# LEEDS BRADFORD AIRPORT FASI AIRSPACE CHANGE PROPOSAL

**ACP-2021-066**

## Appendix C ACP Stakeholder Feedback Report

**January 2026**

### Question 1: D32 - NW - A

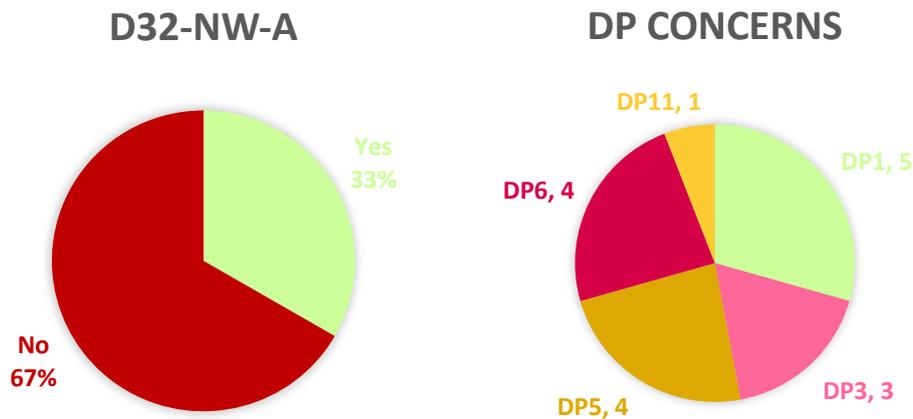
Stakeholder	Feedback
York Gliding Centre, Rufforth West Airfield	Yes; DP1: Difficult to comment authoritatively without information about Flight Level at different distances along the potential swathe;
Peak District National Park Authority	Whilst the swathe may meet most principles, it does not include overflight of a noise sensitive location, namely the Yorkshire Dales National Park (slide 7). This includes Malham & Malham Cove. The aerial view and mapped view (slide 8) appear to be discrepant, No;
Dales Hang gliding & Paragliding Club (DHPC)	No; DP3: AMBER: Potential conflict with YDNP. DPs 1, 5 & 6: We are unable to make meaningful comment until details of the proposed controlled airspace have been promulgated. The safety implications for users outside CAS cannot be properly assessed at this stage. Until they are, we recommend that these DPs be colour coded Amber.
Wolds Gliding Club	No; The published swathe runs through class G airspace utilised by gliders. Without specific airspace height information we cannot accurately assess the impact of

the change. Therefore, we must assume that it may lead to conflict with gliders and fails to meet DP1 DP5 DP6.
<b>North West Leeds Transport Forum</b>	No; It is unclear why there were no other options identified for departures to NW from RW32. For example, why not have a swathe turning North to head over Weston Park before turning NW (this would be more compliant with principle 2 because it would reduce overflying of south Burley in Wharfedale and north Menston - although it might require a larger controlled area). Also, we have a general comment on ALL the departure swathes – namely why does a swathe have to be 4.5nm wide at 7000 ft – surely PBN would allow them to be much narrower and thus does a 4.5nm wide swathe conflict with Design Principle 11?
<b>Regional Soaring Airspace Group (RSAG)</b>	No; DPs 1, 5 & 6 AMBER: Our initial assessment based on our knowledge of the area and LBA's own evaluation. However, we reserve our position until details of any proposed airspace are supplied in order for RSAG members to fully understand the ramifications on other airspace users.;

<b>City of Bradford Metropolitan District Council</b>	No; DP3 overflies Ilkley Moor;
<b>British Gliding Association</b>	No; It is difficult to ascertain how DPs 1, 5 and 6 have been applied as there does not appear to be any airspace design proposed at stage 2 so any impact on us as a stakeholder is unclear. Lowering or increasing controlled airspace generally has a detrimental impact on gliding. We refer you to the response of the Regional Soaring Airspace Group.;
<b>Bramhope &amp; Carlton Paris Council</b>	DP3 - the swathe overflies Ilkley Moor, arguably a rural area much used for leisure activities. However, the height at which aircraft pass is a significant fact that may result in little noise.

### Question 4: D32-NE-C

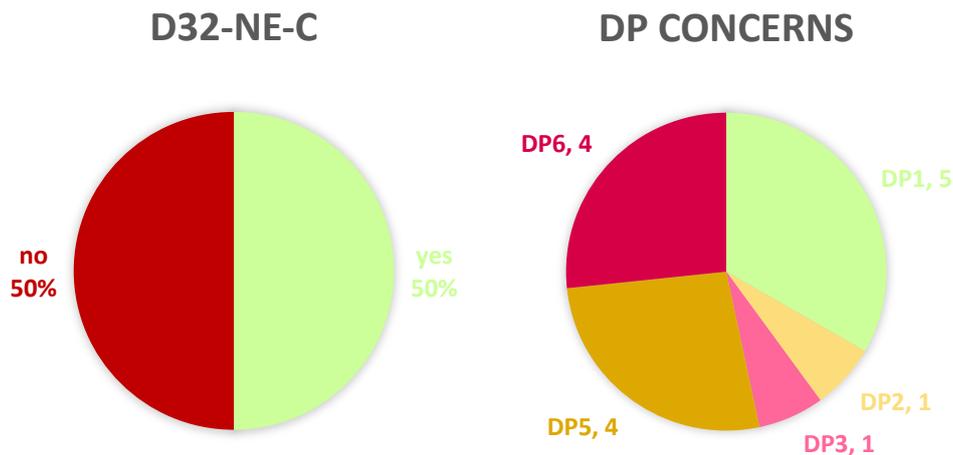
<b>Stakeholder</b>	<b>Feedback</b>
<b>York Gliding Centre, Rufforth Airfield</b>	No; DP1: There is no recognition of the Temporary Reserved Areas for Gliders (TRA(G)) [AIP ENR 6- 64/65] or the Non Secondary Surveillance Radar Gliding Areas [AIP ENR 6-63], or of the likelihood of encountering gliders in mountain wave above FL100 in swathe 32NE-C and 32NE-D;
<b>Dales Hang gliding &amp; Paragliding Club (DHPC)</b>	No; DP3: AMBER: Potential conflict with Nidderdale AONB. DPs 1, 5 & 6: AMBER. We are unable to make meaningful comment until details of the proposed controlled airspace have been promulgated. The safety implications for users outside CAS cannot be properly assessed at this stage. Until they are, we recommend that these DPs be colour coded amber.;
<b>Wolds Gliding Club</b>	Same as Q1.
<b>North West Leeds Transport Forum</b>	No;(2) it overflies Burley in Wharfedale (though avoids overflying Menston);

### Question 5: D32-NE-D

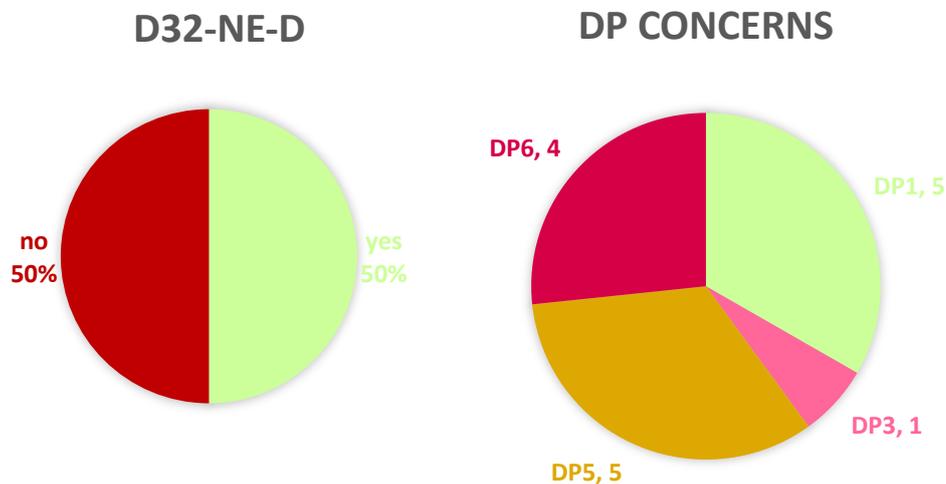
Stakeholder	Feedback
York Gliding Centre, Rufforth Airfield.	No; DP1: There is no recognition of the Temporary Reserved Areas for Gliders (TRA(G)) [AIP ENR 6- 64/65] or the Non- Secondary Surveillance Radar Gliding Areas [AIP ENR 6-63], or of the likelihood of encountering gliders in mountain wave above FL100 in swathe 32NE-C and 32NE-D;
Dales Hang gliding & Paragliding Club (DHPC)	No; DP3: AMBER: Potential conflict with Nidderdale AONB. DPs 1, 5 & 6: AMBER. We are unable to make meaningful comment until details of the proposed controlled airspace have been promulgated. The safety implications for users outside CAS cannot be properly assessed at this stage. Until they are, we recommend that these DPs be colour coded amber.;
Wolds Gliding Club	Same as Q1.

### Question 6: D32-NE-E

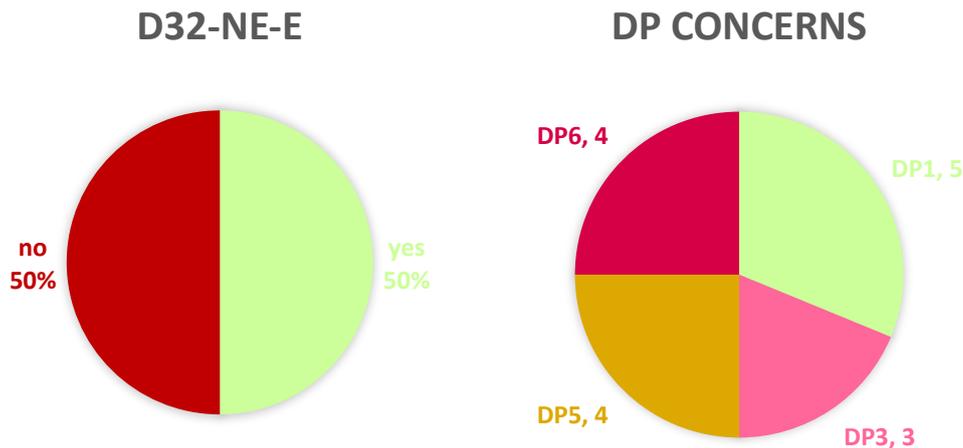
Stakeholder	Feedback
<b>York Gliding Centre, Rufforth Airfield</b>	Yes; DP1: However, we do need to understand more fully the flight levels anticipated at points along the swathe and the entry point into NATS controlled airspace to be sure,;
<b>Peak District National Park Authority</b>	No recognition under DP3 of overflight of Yorkshire Dales National Park; No;
<b>Dales Hang gliding and Paragliding Club (DHPC)</b>	No; DP 3: AMBER: Potential conflict with YDNP. DPs 1, 5 & 6: AMBER. We are unable to make meaningful comment until details of the proposed controlled airspace have been promulgated. The safety

### Question 7: D32-SE-A

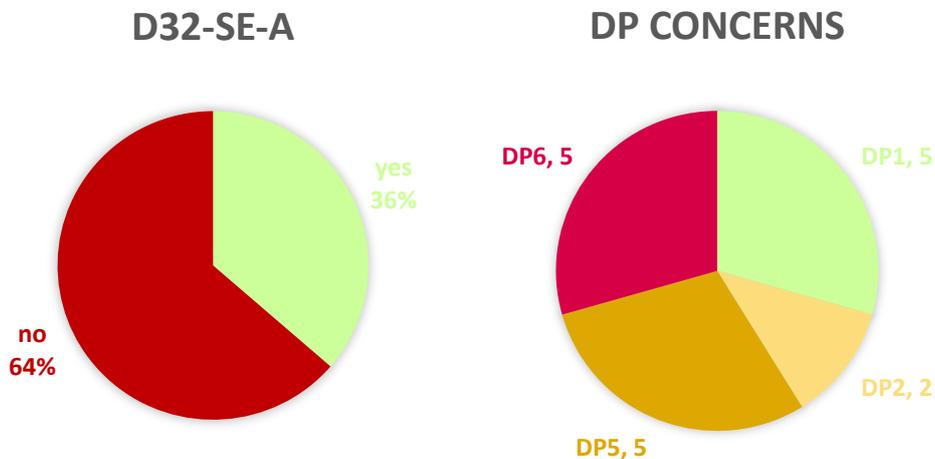
Secondary Surveillance Radar Gliding Areas [AIP ENR 6-63], or of the likelihood of encountering gliders in thermal up to cloud base and in mountain wave above FL100 in swathe 32SE-A.;
<b>Dales Hang gliding and Paragliding Club (DHPC)</b>	No; DPs 1, 5 & 6: AMBER. We are unable to make meaningful comment until details of the proposed controlled airspace have been promulgated. The safety implications for users outside CAS cannot be properly assessed at this stage. Until they are, we recommend that these DPs be colour coded amber.;
<b>Wolds Gliding Club</b>	Same as Q1.
<b>North West Leeds Transport Forum</b>	No;(2) it overflies Bramhope. (5) requires larger controlled airspace (6) possible conflict with arrivals;
<b>Regional Soaring Airspace Group (RSAG)</b>	No; DPs 1, 5 & 6 RED: Our initial assessment based on our knowledge of the area and LBA's own evaluation. We are concerned that your documentation does not acknowledge the existence of the Temporary Reserved Areas for Gliders (TRA(G)) [AIP ENR 6- 64/65] or the Non- Secondary Surveillance Radar Gliding Areas [AIP ENR 6-63]. Moreover, gliders are likely to operate above FL100 in mountain wave conditions in swathe 32SE-A. Accordingly, we reserve our position until details of any proposed airspace are supplied in order for RSAG members to fully understand the ramifications on other airspace users. ;

<b>British Gliding Association</b>	Same as Q1.
<b>Bramhope &amp; Carlton Parish Council</b>	DP 2 Unclear what the comment "Baseline affects less people at lower levels than this option - Burley in Wharfedale / Bramhope"

### Question 8: D32-SE-B

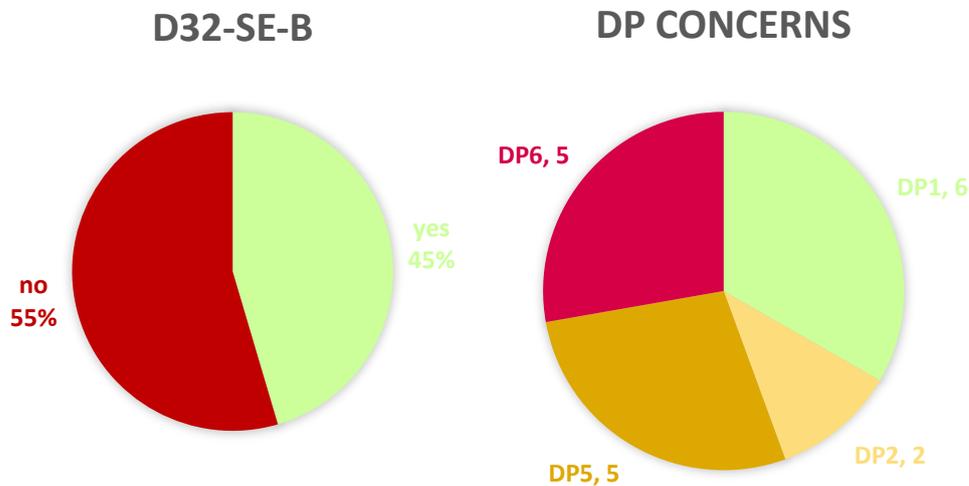
Stakeholder	Feedback
York Gliding Centre, Rufforth Airfield	No; DP1: It is also not clear if swathe 32SE-B will affect the agreement between DSA and the BGA to raise the floor of DSA CTA 8 & 9 in thermic soaring conditions (The 'Upton Corridor');
Dales Hang Gliding and Paragliding Club (DHPC)	No; DPs 1, 5 & 6: AMBER. We are unable to make meaningful comment until details of the proposed controlled airspace have been promulgated. The safety implications for users outside CAS cannot be properly assessed at this stage. Until they are, we recommend that these DPs be colour coded amber.;
Wolds Gliding Club	Same as Q1.
North West Leeds Transport Forum	No;(1) possible conflict over heavily built up area. (2) it overflies Bramhope and large areas of Leeds. (5) requires larger controlled airspace. (6) possible conflict with arrivals.;
Regional Soaring Airspace Group (RSAG)	No;DPs 1 ,5 & 6 RED: Our initial assessment based on our knowledge of the area and LBA's own evaluation. We require

### Question 9: D32-SE-C

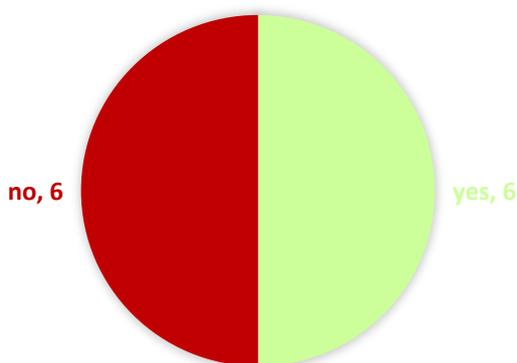
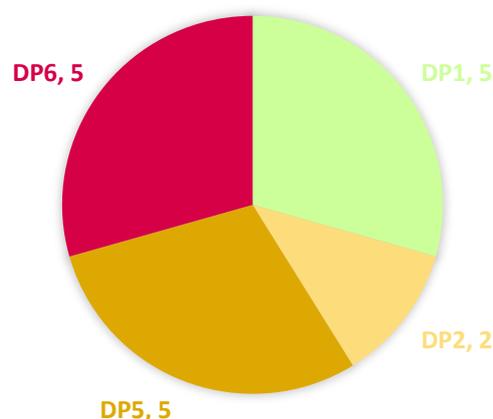
Stakeholder	Feedback
Dales Hang gliding and Paragliding Club	No; DPs 1, 5 & 6: AMBER. We are unable to make meaningful comment until details of the proposed controlled airspace have been promulgated. The safety implications for users outside CAS cannot be properly assessed at this stage. Until they are, we recommend that these DPs be colour coded amber.;
Wolds Gliding Club	Same as Q1.
North West Leeds Transport Forum	No;(1) possible conflict over heavily built up area. (2) overflies Bramhope and large areas of Leeds. (5) requires larger controlled airspace. (6) possible conflict with arrivals.;
Regional Soaring Airspace Group (RSAG)	No; DPs 1, 5 & 6 RED: Our initial assessment based on our knowledge of the area and LBA's own evaluation. However, we reserve our position until details of any proposed airspace are supplied in order for RSAG members to fully understand the ramifications on other airspace users. ;

British Gliding Association	Same as Q1.
Bramhope & Carlton Parish Council	DP 2 Unclear what the comment "Baseline affects less people at lower levels than this option - Burley in Wharfedale / Bramhope

### Question 10: D32-SE-D

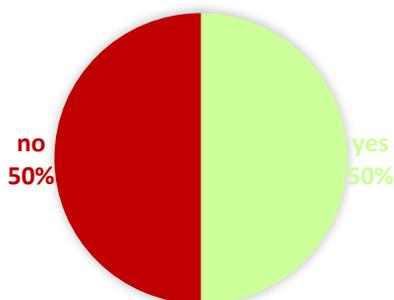
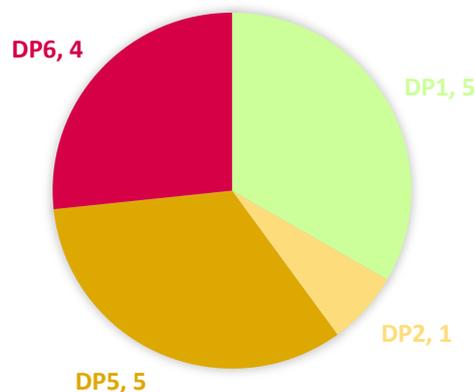
Stakeholder	Feedback
<b>Dales Hang gliding &amp; Paragliding Club (DHPC)</b>	No; DPs 1, 5 & 6: AMBER. We are unable to make meaningful comment until details of the proposed controlled airspace have been promulgated. The safety implications for users outside CAS cannot be properly assessed at this stage. Until they are, we recommend that these DPs be colour coded amber.;
<b>Wolds Gliding Club</b>	No; The published swathe runs through class G airspace utilised by gliders. Without specific airspace height information we cannot accurately assess the impact of the change. Therefore, we must assume that it may lead to conflict with gliders and fails to meet DP1 DP5 DP6.;
<b>North West Leeds Transport Forum</b>	No;(2) it overflies Baildon, Bingley, Shipley and Bradford;
<b>Regional Soaring Airspace Group</b>	No; DPs 1, 5 & 6 AMBER: Our initial assessment based on our knowledge of the area and LBA's own evaluation. However, we reserve our position until details of any proposed airspace are supplied in order for RSAG members to fully understand the ramifications on other airspace users. ;

<b>City of Bradford Metropolitan District Council</b>	No;DP3 overflies Ilkley Moor, Bradford;
<b>British Gliding Association</b>	It is difficult to ascertain how DPs 1, 5 and 6 have been applied as there does not appear to be any airspace design proposed at stage 2 so any impact on us as a stakeholder is unclear. Lowering or increasing controlled airspace generally has a detrimental impact on gliding. We refer you to the response of the Regional Soaring Airspace Group.; No;

### Question 11: D32-SE-E

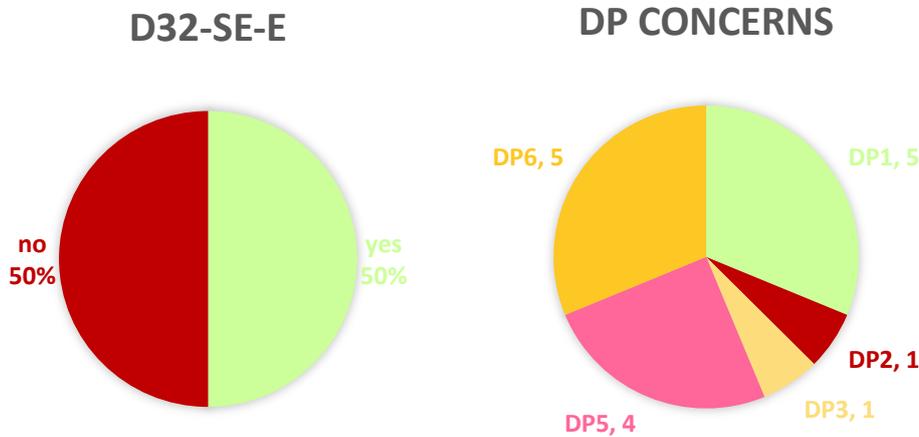
Stakeholder	Feedback
Dales Hang gliding & Paragliding Club (DHPC)	No; DPs 1, 5 & 6: AMBER. We are unable to make meaningful comment until details of the proposed controlled airspace have been promulgated. The safety implications for users outside CAS cannot be properly assessed at this stage. Until they are, we recommend that these DPs be colour coded amber.;
Wolds Gliding Club	No; The published swathe runs through class G airspace utilised by gliders. Without specific airspace height information we cannot accurately assess the impact of the change. Therefore, we must assume that it may lead to conflict with gliders and fails to meet DP1 DP5 DP6.;
North West Leeds Transport Forum	No;(1) possible conflict over heavily built up area. (2) it overflies Baildon, Bingley, Shipley, Bradford and Leeds. (6) possible conflict with arrivals.;
Regional Soaring Airspace Group (RSAG)	Same as Q1.
City of Bradford Metropolitan District Council	No;DP3 overflies Ilkley Moor, Bradford;

### Question 12: D32-S&W-A

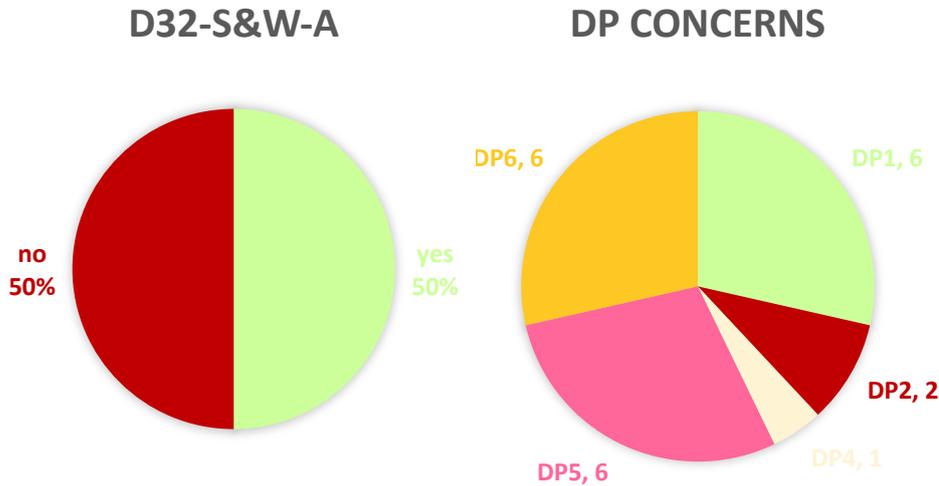
Stakeholder	Feedback
<b>Dales Hang gliding &amp; Paragliding Club (DHPC)</b>	No; DPs 1, 5 & 6: AMBER. We are unable to make meaningful comment until details of the proposed controlled airspace have been promulgated. The safety implications for users outside CAS cannot be properly assessed at this stage. Until they are, we recommend that these DPs be colour coded amber.;
<b>Wolds Gliding Club</b>	No; The published swathe runs through class G airspace utilised by gliders. Without specific airspace height information we cannot accurately assess the impact of the change. Therefore, we must assume that it may lead to conflict with gliders and fails to meet DP1 DP5 DP6.;
<b>North West Leeds Transport Forum</b>	No;(1) possible conflict over heavily built up area. (2) it overflies Baildon, Bingley, Shipley, Bradford and Leeds. (6) possible conflict with arrivals.;
<b>Regional Soaring Airspace Group (RSAG)</b>	<i>Same as Q1.</i>

<b>City of Bradford Metropolitan District Council</b>	No; DP3 overflies Ilkley Moor, Bradford;
<b>British Gliding Association</b>	Same as Q1.
<b>Bramhope &amp; Carlton Parish Council</b>	DP2 - as before Unclear what the comment "Baseline affects less people at lower levels than this option - Burley in Wharfedale / Bramhope"

### Question 13: D32-S&W-B

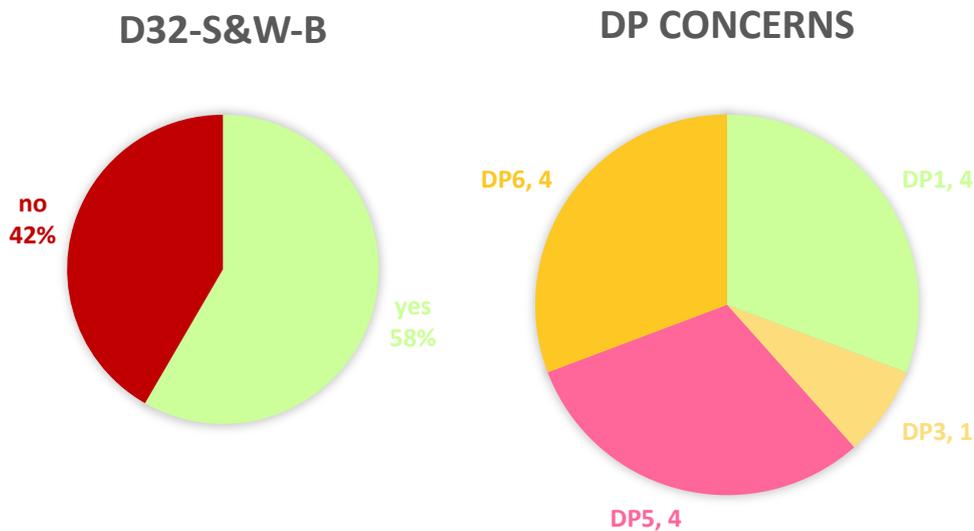
<b>Stakeholder</b>	<b>Feedback</b>
<b>Dales Hang gliding and Paragliding Club (DHPC)</b>	No; DPs 1, 5 & 6: AMBER. We are unable to make meaningful comment until details of the proposed controlled airspace have been promulgated. The safety implications for users outside CAS cannot be properly assessed at this stage. Until they are, we recommend that these DPs be colour coded amber.;
<b>Wolds Gliding Club</b>	No;The published swathe runs through class G airspace utilised by gliders. Without specific airspace height information we cannot accurately assess the impact of the change. Therefore, we must assume that it

### Question 14: D32-S&W-C

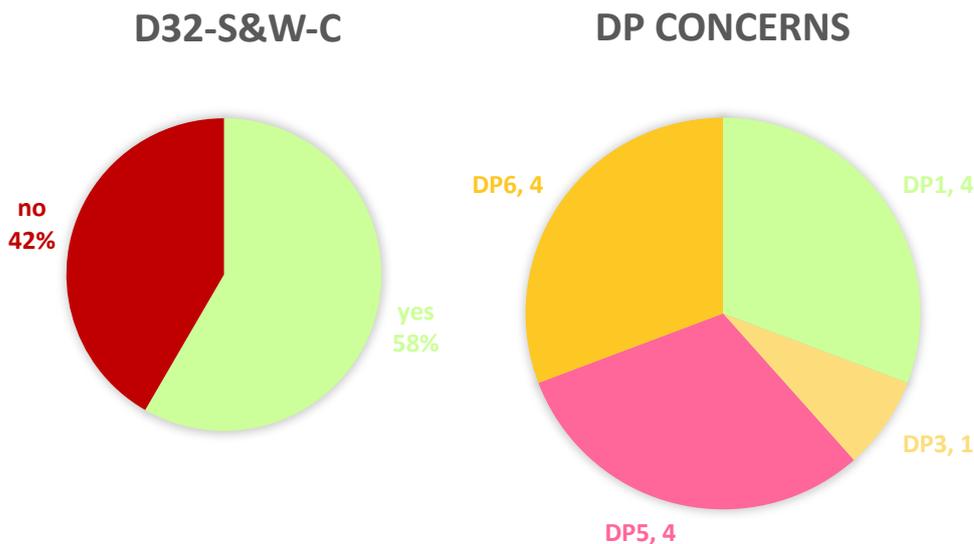
Stakeholder	Feedback
<b>Dales Hang gliding and Paragliding Club (DHPC)</b>	No; DPs 1, 5 & 6: AMBER. We are unable to make meaningful comment until details of the proposed controlled airspace have been promulgated. The safety implications for users outside CAS cannot be properly assessed at this stage. Until they are, we recommend that these DPs be colour coded amber.;

<b>Wolds Gliding Club</b>	No; The published swathe runs through class G airspace utilised by gliders. Without specific airspace height information we cannot accurately assess the impact of the change. Therefore, we must assume that it may lead to conflict with gliders and fails to meet DP1 DP5 DP6.;
<b>Regional Soaring Airspace Group (RSAG)</b>	No; DPs 1, 5 & 6 AMBER: Our initial assessment based on our knowledge of the area and LBA's own evaluation. However, we reserve our position until details of any proposed airspace are supplied in order for RSAG members to fully understand the ramifications on other airspace users. ;
<b>City of Bradford Metropolitan District Council</b>	No; DP3 overflies Ilkley Moor;
<b>British Gliding Association</b>	Same as Q1.

### Question 15: D32-S&W-D

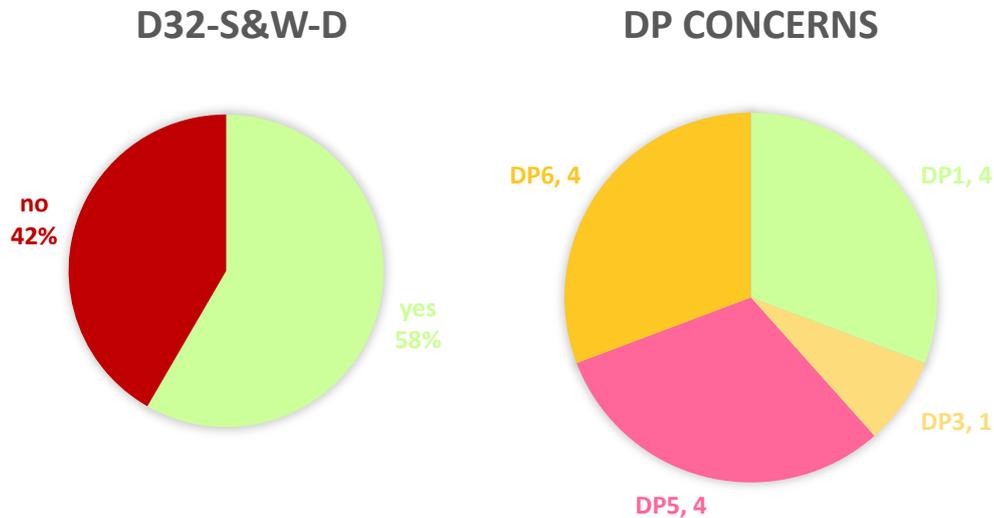
<b>Stakeholder</b>	<b>Feedback</b>
<b>Dales Hang gliding and Paragliding Club (DHPC)</b>	No; DPs 1, 5 & 6: AMBER. We are unable to make meaningful comment until details of the proposed controlled airspace have been promulgated. The safety implications for

users outside CAS cannot be properly assessed at this stage. Until they are, we recommend that these DPs be colour coded amber.;
<b>Wolds Gliding Club</b>	No; The published swathe runs through class G airspace utilised by gliders. Without specific airspace height information we cannot accurately assess the impact of the change. Therefore, we must assume that it may lead to conflict with gliders and fails to meet DP1 DP5 DP6.;
<b>Regional Soaring Airspace Group (RSAG)</b>	Same as Q1.
<b>City of Bradford Metropolitan District Council</b>	No; DP3 overflies Ilkley Moor;
<b>British Gliding Association</b>	Same as Q1.

### Question 16: D32-S&W-E

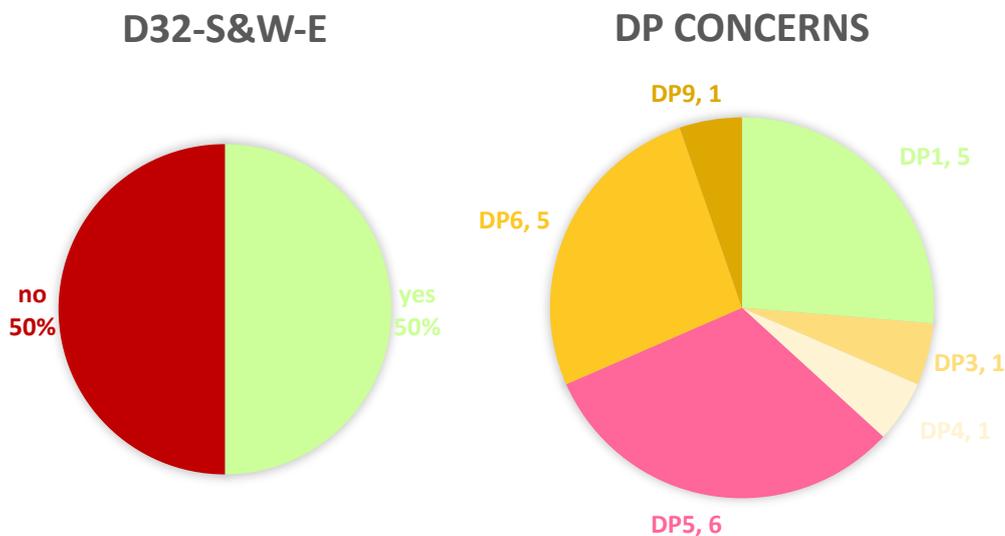
Stakeholder	Feedback
<b>Dales Hang gliding and Paragliding Club (DHPC)</b>	No; DP 3: AMBER: Overflies Ilkley Moor and YDNP. DPs 1, 5 & 6: AMBER. We are unable to make meaningful comment until details of

the proposed controlled airspace have been promulgated. The safety implications for users outside CAS cannot be properly assessed at this stage. Until they are, we recommend that these DPs be colour coded amber.;
<b>Wolds Gliding Club</b>	No; The published swathe runs through class G airspace utilised by gliders. Without specific airspace height information we cannot accurately assess the impact of the change. Therefore, we must assume that it may lead to conflict with gliders and fails to meet DP1 DP5 DP6.;
<b>North West Leeds Transport Forum</b>	No; (4) Extra track miles, (5) requires larger controlled airspace (9) extra track miles;
<b>Regional Soaring Airspace Group (RSAG)</b>	Same as Q1.
<b>City of Bradford Metropolitan District Council</b>	No; DP3 overflies Ilkley Moor;
<b>British Gliding Association</b>	Same as Q1.
